From: Sara Roediger, AICP
 Date: 8/8/2016
 Re: **Henry Ford Pharmacy (City File #16-010)
 Preliminary/Final Site Plan - Planning Review #3**

From: Jason Boughton AC, Engineering Utilities Coordinator
To: Sara Roediger, Manager of Planning
Date: July 27, 2016
Re: Henry Ford Pharmacy, City File #16-010, Section 36
Site Plan Review #3

**Subject: File No. 16-010 Henry Ford Pharmacy;
Wetland Use Permit Review #3;
Plans received by the City of Rochester Hills on
July 22, 2016**

CITY OF ROCHESTER HILLS
 STANDARD DETAIL FOR:
 Sight Distance Pathways

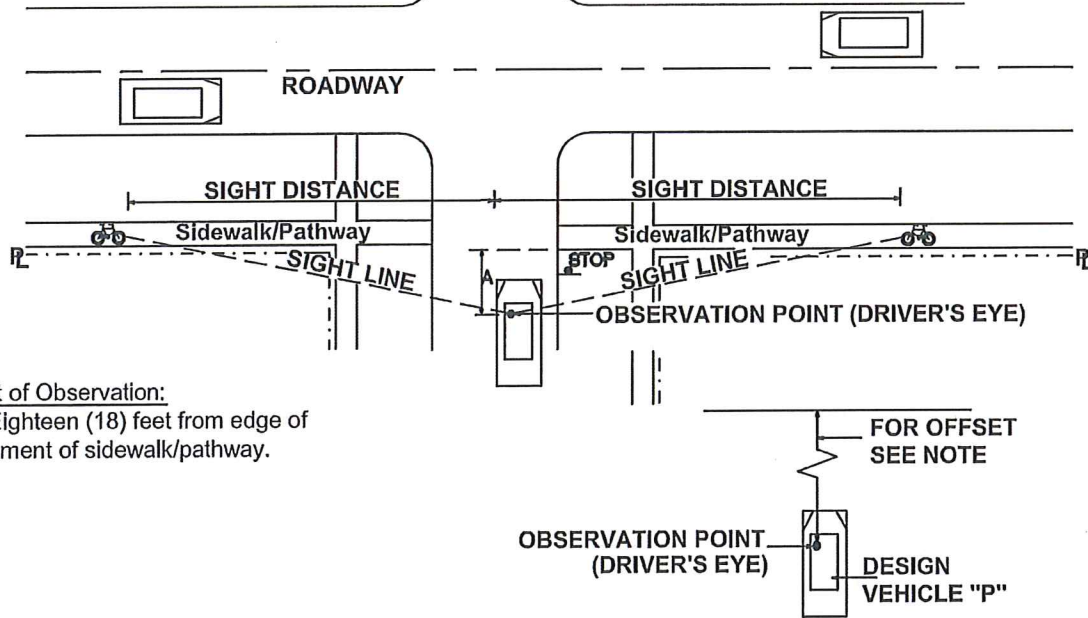
1. On sheet L-1, include sight pathway sight distance lines per the attached detail.
2. The owner has indicated a 27 foot highway easement will be provided. Please note the highway easement will need to be submitted and approved prior to LIP issuance.
3. Provide RCOC permit approval letter.
